SSC UNDERGROUND TECHNOLOGY

**UTAP
REPORT**

**of the Subcommittee
on Management**

RECOMMENDATIONS TO THE
SUPERCONDUCTING SUPER COLLIDER LABORATORY
CONCERNING THE
CONVENTIONAL CONSTRUCTION DIVISION

APPENDIX C

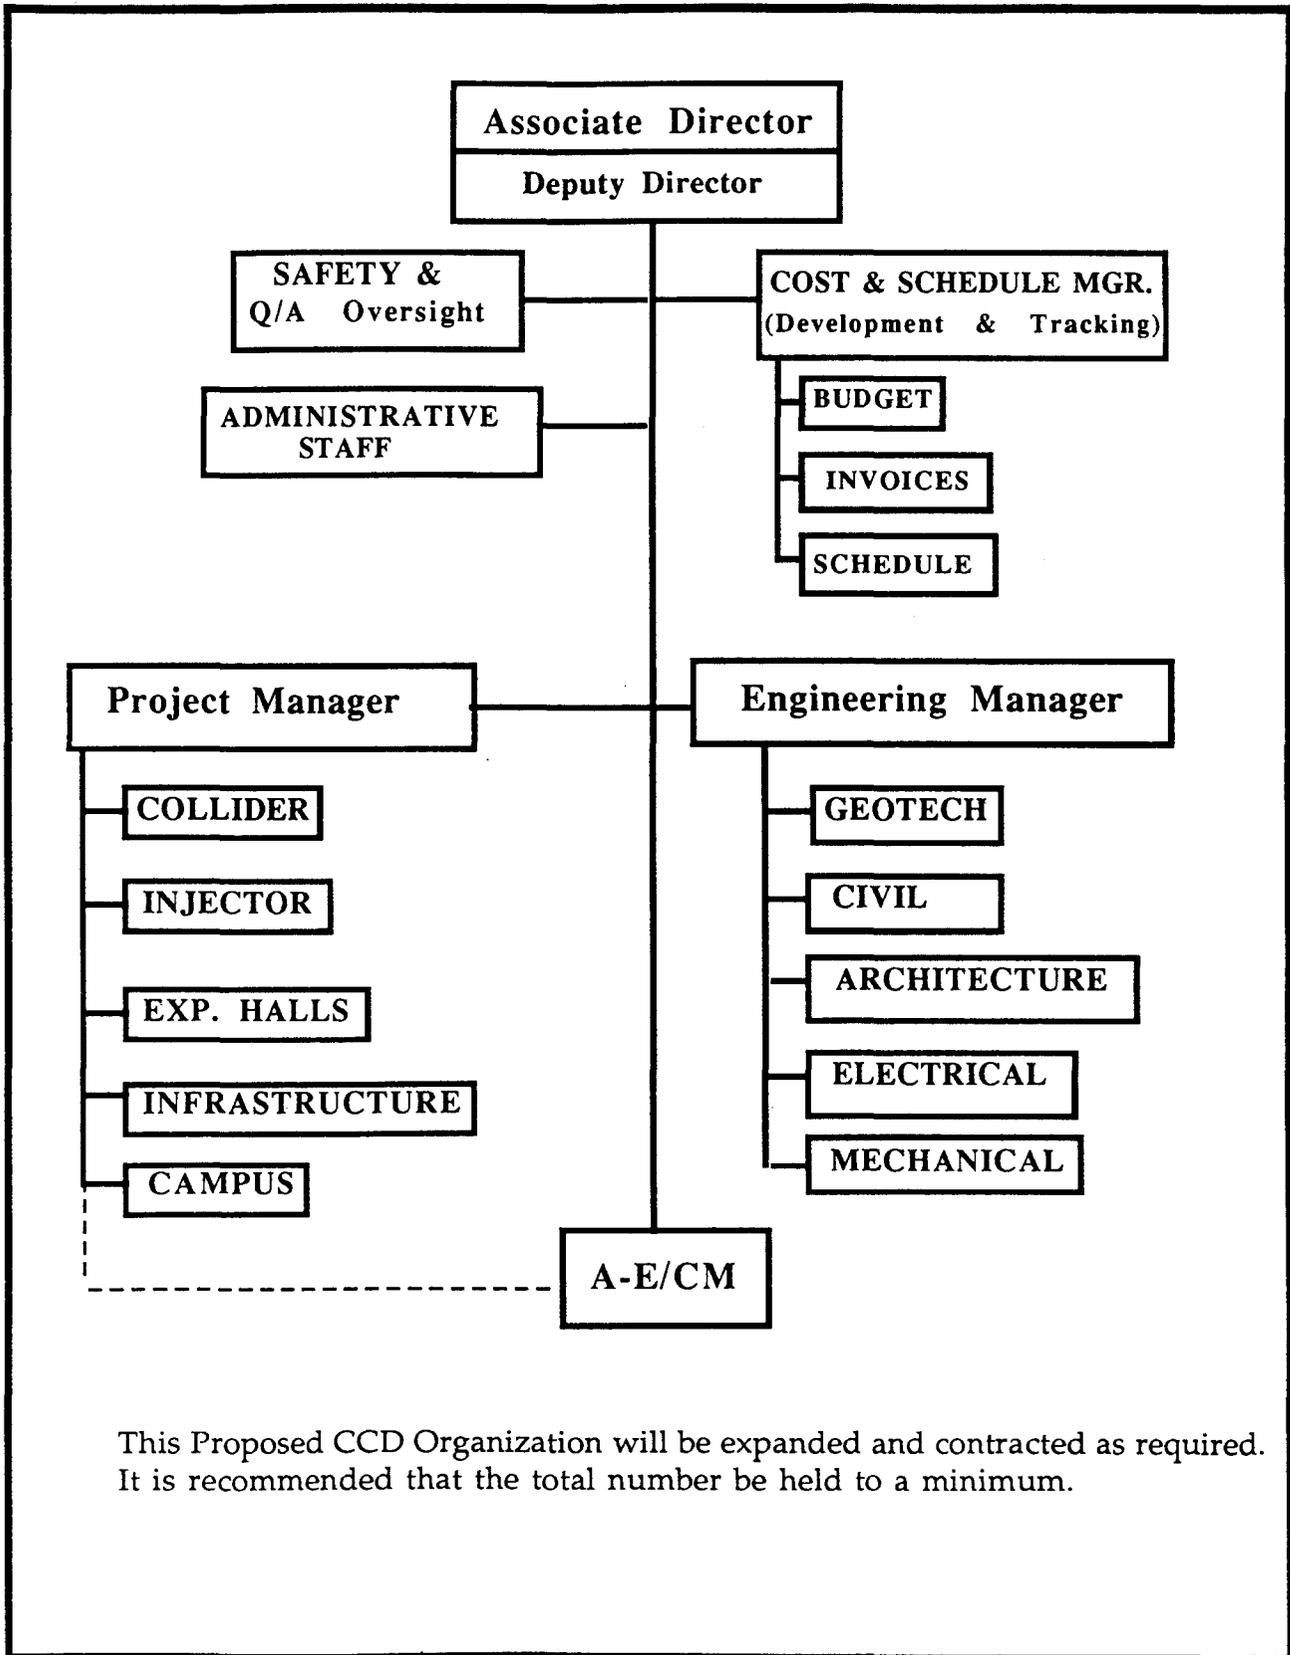
3. Establish and publish an official CCD organization, patterned on the principles discussed above.
4. Two suggested organizations for the CCD are as outlined on Appendix C and D. The chart at Appendix C was proposed by a CCD staff employee. The UTAP feels that a large technical staff is indicated which would duplicate functions performed by the A-E/CM and result in higher cost. The structure outlined in Appendix D appears more streamlined, effective and efficient. It is the CCD organizational structure recommended by the UTAP.
